E4417A-11A

S E R V I C E N O T E

Agilent E4417A EPM-P Peak & Average Power Meter

Front Panel Display Problems Caused by Power Assembly Cable

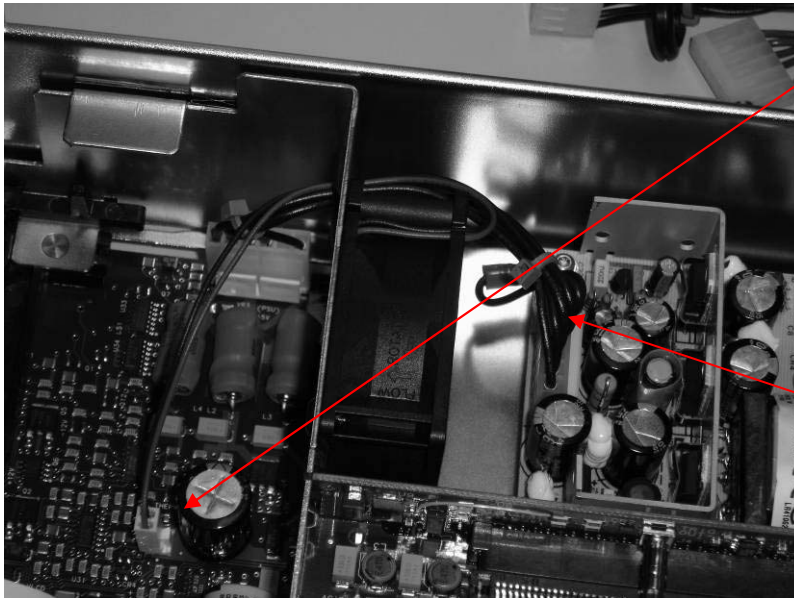
- 3) Remove fan connector and PSU cable assembly and replace with new PSU cable assembly E4418-61005. You can differentiate the cable assembly by the colors. The old cable is Black and new cable is RED.

Fan connector

PSU cable New cable is RED in color

Insert the plastic casing horizontally

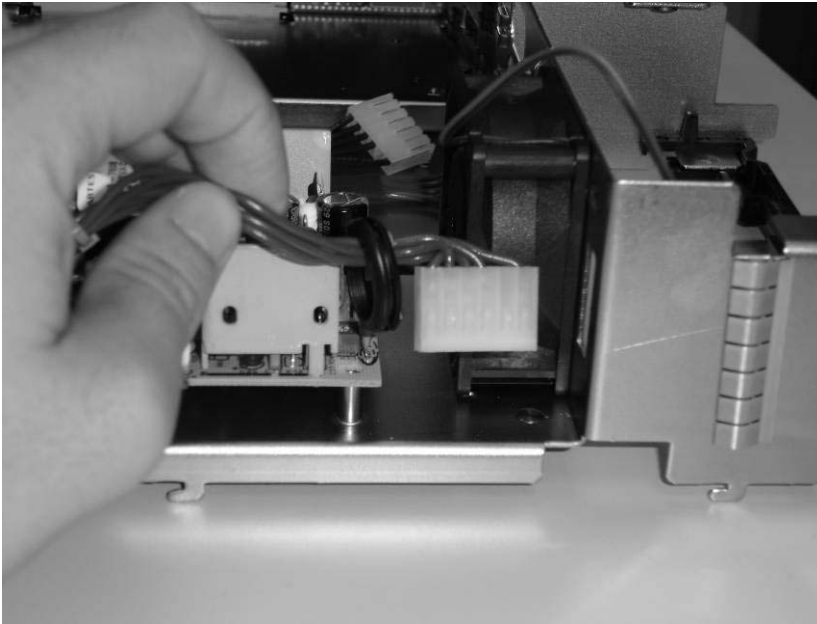
- 5) Here are some tips regarding the new cable. Since the plastic casing is slightly bigger in size, so you cannot directly pass through connector through hole. So you need to insert the cable horizontally. See illustration below.

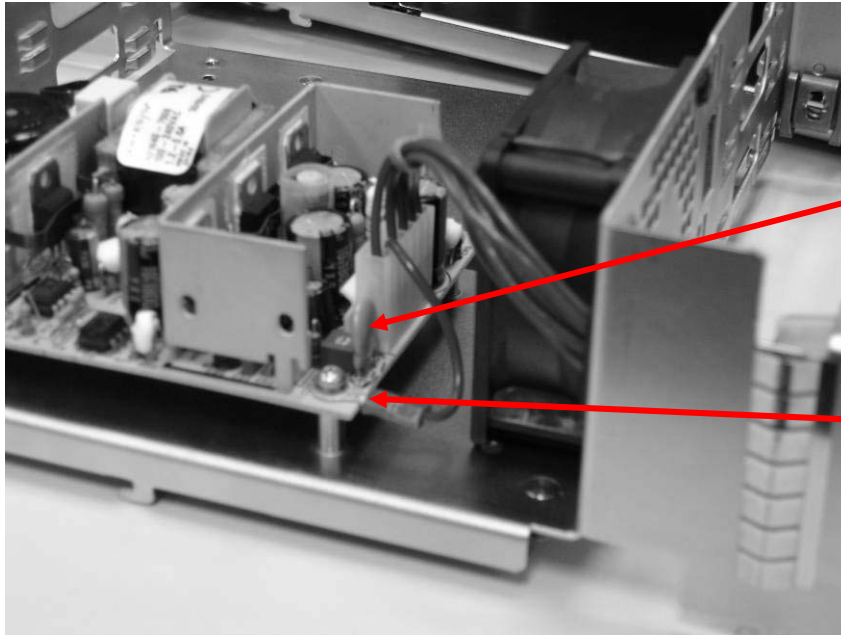
7) Photo below show different of old and new cable. The new cable is red in color whereas the old cable is black in color. The E4418-61005 has 1 ground wire.

New cable assembly

Old cable assembly

Note: If the power cable assembly is red in color, indicates that the cable already been changed. No action is needed.

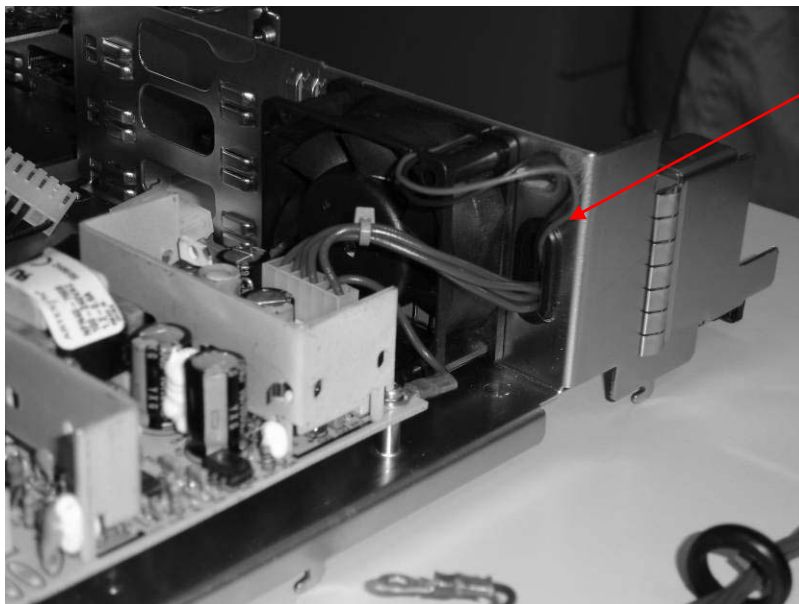
Yellow Capacitor.

Ground wire connected to PCB

10) This picture above shows the ground wire connection to the PCB. Please be aware that the ground connection is very close to the leg of the yellow capacitor. PLEASE DO NOT LET THE GROUND WIRE TOUCHES THE CAPASITOR'S LEG.
